From: Lyon, Fred
Sent: Monday, January 06, 2014 2:11 PM
To: johnsonc20@gmail.com
Cc: washpsr@gmail.com; Banic, Merrilee
Subject: 10 CFR 2.206 Pre-Meeting Call and Requested Letter (G20130776; MF3031)
Attachments: 10-4-13 EN letter to NRC re USACE Dam Analysis.pdf; cgs-seismic 2 206(v3).docx

Subject: **COLUMBIA GENERATING STATION, DOCKET NO. 50-397
ENERGY NORTHWEST'S REQUEST FOR NRC ASSISTANCE TO
OBTAIN INFORMATION FROM THE US ARMY CORPS OF ENGINEERS
(USACE) RELATED TO DAM FAILURE ANALYSIS**

Columbia Generating Station
Seismic Hazard Considerations
Determination of Immediate Safety Concerns
G20130776

Figure 1: SSE GROUND MOTION RESPONSE SPECTRUM

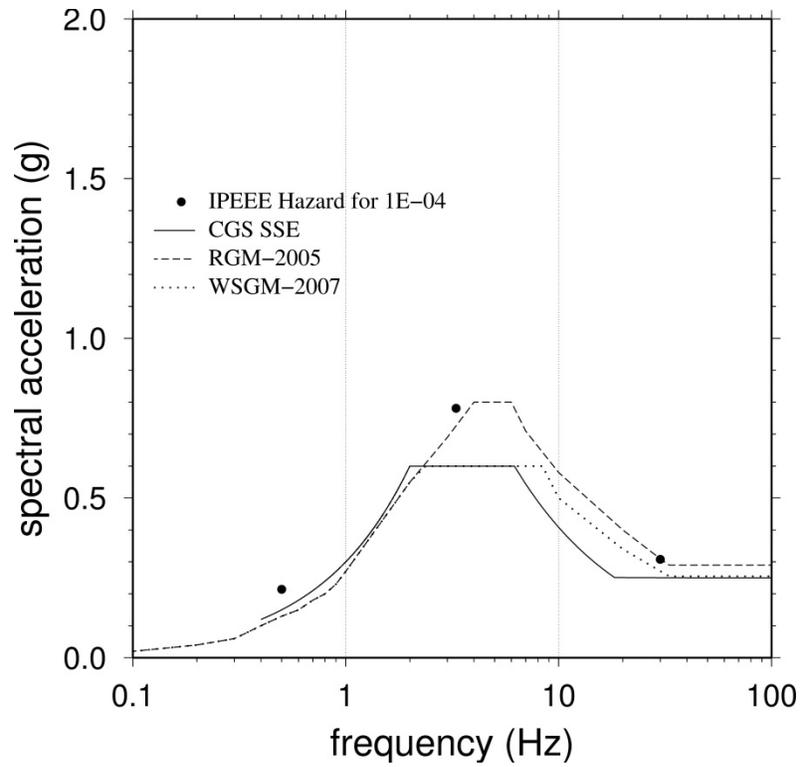
- The seismic design for the Columbia Generating Station (CGS) plant is represented by the SSE ground motion response spectrum, as shown in Figure 1 below (solid curve).

- The CGS SSE spectrum is anchored at an acceleration level of 0.25 g, but is much higher (up to 0.6 g) over the important frequency range of 2 to 10 Hz where plant structures and systems are most sensitive to earthquake ground motions.

- The licensee evaluated the impact on the CGS plant from potential seismic ground motions from several regional seismic sources over a wide range of hazard levels (the 1/10,000 mean hazard levels are shown as circles in Figure 1 below).

- The Department of Energy (DOE) evaluated the seismic hazards for the seismic design of the Waste Treatment and Immobilization Plant (WTP) at the Hanford site in 1995, 2005, and 2007.
 - The most recent WTP seismic design spectra are shown below as the dashed (2005) and dotted (2007) curves.
 - The most recent seismic hazard evaluation for the design of the WTP in 2007 is very similar to the CGS seismic design or SSE.
 - In its letter to the Chairman dated October 31, 2013, the Oregon and Washington Physicians for Social Responsibility (OWPSR) mistakenly compares the 3 to 5 Hz spectral acceleration level of 0.8g for the WTP 2005 seismic design with the CGS SSE 20 Hz and greater spectral acceleration value of 0.25g.

Conclusion:
